Product Change Notification

Change Notification #: 109349 - 00
Change Title: Intel Gigabit CT Desktop Adapters,
EXPI9301CTG1P20 MM#895799,
EXPI9301CT MM#893646 and
EXPI9301CTBLK MM#893647
(code named Shelter Island OEM/Retail)

Clamshell and Box change from Medium to Small

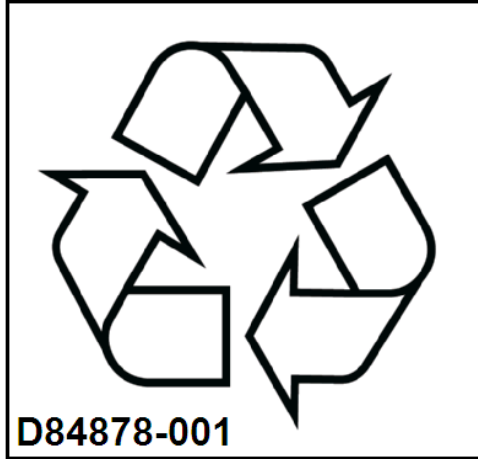
As a result of this box change we will also make the following label change.
Cardboard Recycle Logo Label Change:

Intel will remove the cardboard recycle Label from all shipping boxes and replace with a pre-printed version on the box. This will eliminate the need for extra labels to be placed on boxes at our manufacturing facilities. A picture of this recycle label is shown below.
